Re: **Colorado River Interim Surplus Criteria Draft Environmental
Impact Statement (July 2000)**

**TEN TRIBES PARTNERSHIP COMMENTS ON THE
COLORADO RIVER INTERIM SURPLUS CRITERIA
DRAFT ENVIRONMENTAL IMPACT STATEMENT**

Figure 1. Different combinations of Tribal Accounting Pool (TAP) and contents of Lake Mead relative to surplus (+) and shortage (-) trigger elevations.

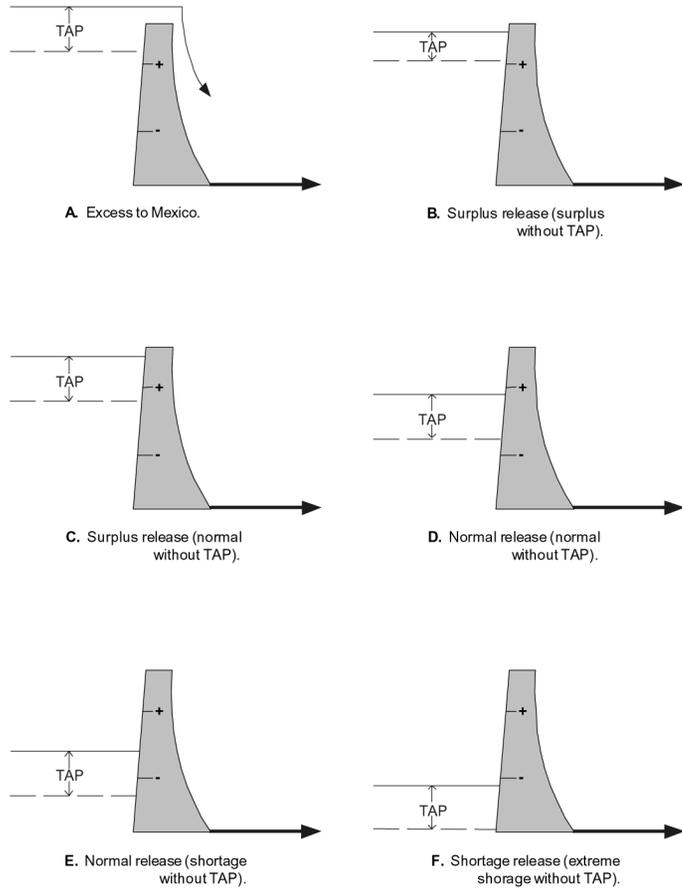
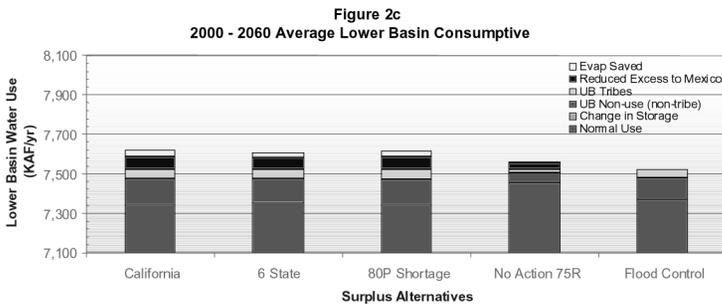
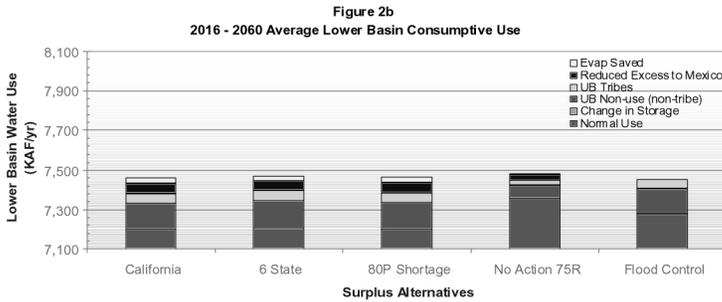
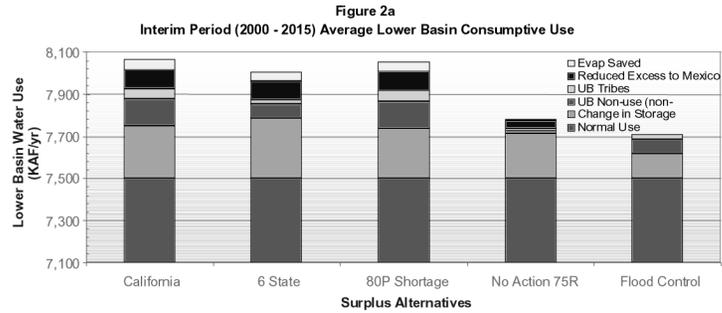
The Lower Basin presently exceeds its compact apportionment, even though the Lower Basin Tribes have not fully developed their perfected water rights. This undeveloped portion of the Lower Basin Tribal depletion right is represented in all analyses as its proportionate share of the Lower Basin use, indicating that other users in the Lower Basin are presently consuming these depletion rights. In addition, this undeveloped portion of Lower Basin Partnership water could be tracked by in-reservoir accounting in Lake Mead explained in more detail below.

Because the undeveloped Five Lower Basin Tribes' water assets are an implicit component of the Lower Basin consumptive use they should be treated differently than the undeveloped Upper Basin water when analyzing the potential effects of the various surplus criteria.

Since the Lower Colorado River Basin States presently receive more than their 7.5 million acre-feet (MAF) apportionment, even though the Five Lower Basin Tribes have not fully developed their decreed right, the Lower Basin is implicitly using and relying on Tribal water. The consequence of undeveloped Lower Basin Tribal water could be tracked as the difference between model runs with and without full development as for the Upper Basin Tribal water. While tracking the Lower Basin Tribal rights on this annual basis is instructive and important to the Partnership, it is not a meaningful accounting method that reflects the true value of this trust asset. Impacts accounted for in this manner do not clearly reflect the value of the Tribal water thus used by others. For example, in wet periods when excess water is available, there would be no use of this water by others, yet in dry years its use becomes very important in off-setting shortages that would exist otherwise. Another accounting instrument is required that better represents this differential use. Accordingly, Partnership proposes to represent their unused Lower Basin water with in-reservoir accounting in Lake Mead. In addition to better assessing the use of Lower Basin Tribal water, this accounting method allows differential assessment of impacts among the alternatives. Such an accounting method

Figure 1 shows various storage conditions in Lake Mead relative to surplus (+) and shortage (-) trigger elevations.

- a) Under the condition shown in Figure 1a excess water would be delivered to Mexico and TAP would be reduced by the amount of excess. If the excess to Mexico exceeds the amount in TAP, TAP contents would be zeroed. The sharing of impact with top water banks discussed above would apply to this condition.
- b) The condition shown in Figure 1b would result in a surplus delivery with or without TAP and no water would be withdrawn from TAP.
- c) Under the condition shown in Figure 1c a surplus would be declared. Without TAP a normal release (no surplus) would be declared. Because it is the contents of TAP that put the lake level above the surplus trigger elevation and allow a surplus to be declared, an amount equal to the lesser of the surplus and TAP contents would be added to the tally of surplus water resulting from the undeveloped Lower Basin Tribal water and withdrawn from TAP.

- d) The condition shown in Figure 1d would result in a normal delivery with or without TAP and no water would be withdrawn from TAP.
- e) Under the condition shown in Figure 1e a normal delivery would be declared. Without TAP shortage would occur. Since it is the contents of TAP that put the lake level above the shortage trigger elevation and allow normal delivery rather than shortage, an amount equal to the lesser of TAP and the difference between normal and shortage deliveries would be added to the tally of normal water (shortage relief) resulting from the undeveloped Lower Basin Tribal water and withdrawn from TAP.

- f) Under the condition shown in Figure 1f shortage occurs with or without TAP water; however, to the extent that releases are greater with TAP water than without, the difference would be added to the tally of shortage reduction attributed to the undeveloped Lower Basin Tribal water and withdrawn from TAP.

20: The Department declines the request to adopt a Lower Basin Tribal Accounting Pool.

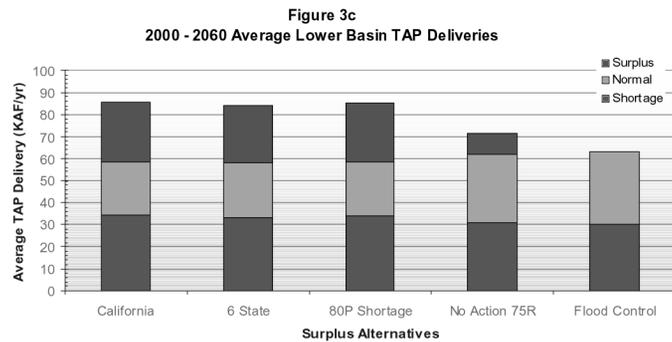
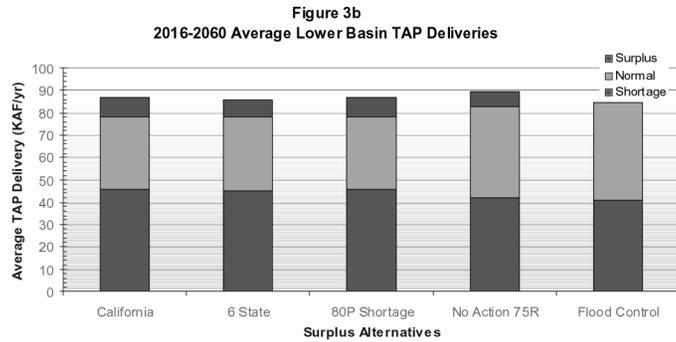
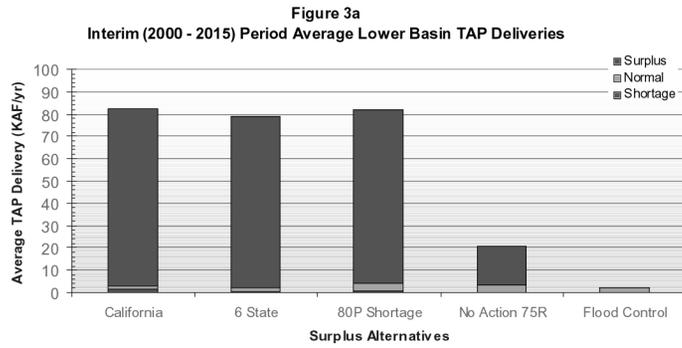
Figure 2a shows that the storage drawdown in Lakes Powell and Mead is the largest source of surplus water to the Lower Basin for all surplus alternatives during the interim period (2000-2015). With the exception of the No Action Alternative, undeveloped water in the Upper Basin is the next largest source of Lower Basin surplus, followed by reduction in spills (excess to Mexico), and then reduced evaporation loss due to the lowering Lakes Powell and Mead.

For the post-interim period (2016-2060), Figure 2b, the average Lower Basin consumptive use is below 7.5 MAF and there is no surplus resulting from change in storage in Lakes Mead and Powell as these reservoirs were effectively drawn down during the interim period. The No Action Alternative produces the greatest Lower Basin consumptive use during the post-interim period and with less than half the dependency on undeveloped Upper Basin water as the other alternatives.

Figure 2c shows the annual averages over the entire 60-year modeling period. Because the change in storage over the entire modeling period is practically the same for all alternatives it does not figure in to a 60-year average comparison of the alternatives. Figure 2c as well demonstrates that the No Action Alternative has the least reliance on undeveloped Upper Basin water of all the alternatives.

Figures 3a-c provide an analysis, using a top-water accounting method in Lake Mead, of the implicit use of undeveloped Lower Basin Indian water rights by non-Partnership entities. As mentioned earlier, the Lower Basin currently exceeds its 7.5 MAF apportionment despite underdevelopment of Lower Basin Tribal waters rights. Thus the undeveloped Lower Basin Tribal water rights are a basic component of Lower Basin non-Indian use. The Partnership believes that the implicit use of its undeveloped Lower Basin water can best be analyzed through water accounting methods described earlier. For this analysis the Partnership assumed that on average 155 KAF was deposited in the Tribal Accounting Pool (TAP) each year. The 155 KAF is the average undeveloped

Figure 3a shows a relatively large amount (nearly 80 KAF annually) of TAP water going to realize surplus deliveries (TAP condition shown in Figure 1c) under the California, Six State, and Shortage Protection Alternatives and a modest amount (17 KAF annually) under the No Action Alternative during the interim period. Small amounts of TAP water also go to normal (TAP condition shown in Figure 1e) and extreme shortage relief (TAP condition shown in Figure 1f).

During the post-interim period over 40 KAF annually of TAP water goes to extreme shortage relief and a near equal amount to meet normal deliveries under all surplus alternatives. With exception of the Flood Control Alternative there is little difference in TAP releases among the alternatives during the post-interim period. Note that for the Flood Control Alternative there is never any surplus TAP release (TAP condition shown in Figure 1c) since under this alternative surplus is coincidental with the condition shown in Figure 1a when the TAP is reset.

Figure 3c shows the 60-year average TAP releases. From this figure it is apparent that there is little difference among the liberal criteria (California, Six State, and Shortage Protection Alternatives) with respect to TAP releases and hence to the implicit reliance on undeveloped Lower Basin Tribal waters. The No Action and Flood Control Alternatives have moderately lower 60-year average TAP releases than the three liberal interim criteria.

21: See response to Comment No. 71-16. See also Attachment Q which shows the Ten Tribe depletions and diversions that were used in the FEIS alternatives.
